WSSC Ten Mile Creek Area Sewer Facility Study

Final Clarksburg - Ten Mile Creek Area Sewer Facility Study. The study area totals 980 acres within the Ten Mile Creek watershed, and lies within the 10 Mile Creek Limited Master Plan Amendment. The Facility study has been prepared for the Washington Suburban Sanitary Commission.

Figure 3-12 Alternative 12 - Gravity + 3 Pump Stations and Grinder Pump Systems (No Observation Drive)

**Figure 4-2
Comparison of Pump Station Sizes**

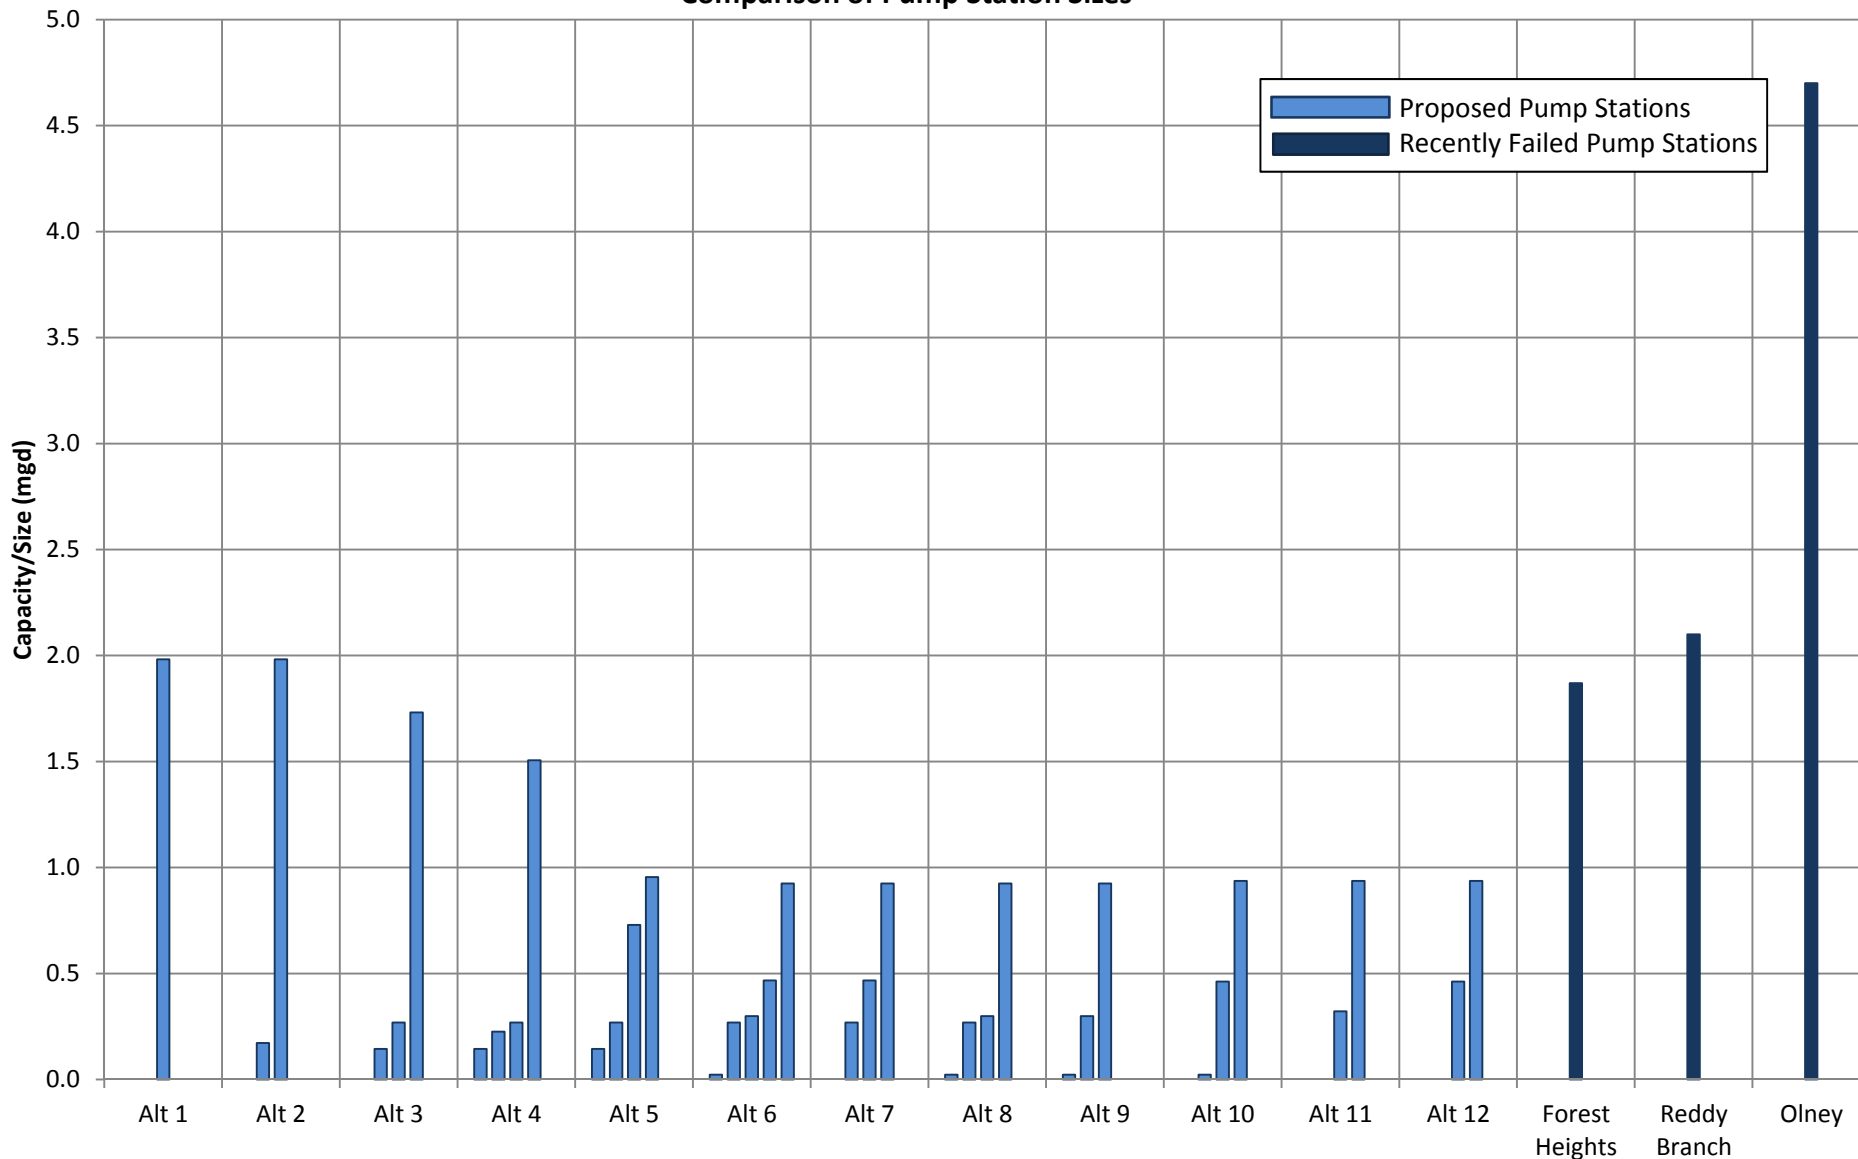
2	12/21/2015	Katherine E. Nelson Planner Coordinator M-NCPPC	<i>11. Figure 4-1 and 4-2 pages 4-14 and 4-15 – Should identify “recently failed” pump stations rather than “existing” pump stations. It implies that these are the only pump stations in the WSSC system.</i>	Revised figures 4-1 and 4-2 in the Final Draft Report to address the comment.
53	12/21/2015	Katherine E. Nelson Planner Coordinator M-NCPPC	<i>12. Figure 4-3 and 4-4 (the Preferred Approaches) – The graphics reference “Grinder Systems” and “grinder pump solution”, but the legend identifies “Low Pressure Sewer”. One term should be used when describing these systems, both on these graphics and in the text.</i>	Revised figures in the Final Draft Report to address the comment.
54	12/21/2015	Katherine E. Nelson Planner Coordinator M-NCPPC	<i>13. Criteria for the successful use of low pressure sewers should be provided by this study. At a minimum, examples of the successful use of low pressure sewers should be provided.</i>	Refer to WSSC SP ENG-04-10, Grinder Systems Policy and Procedure, as to successes we have achieved based on experience and meeting policy requirements.
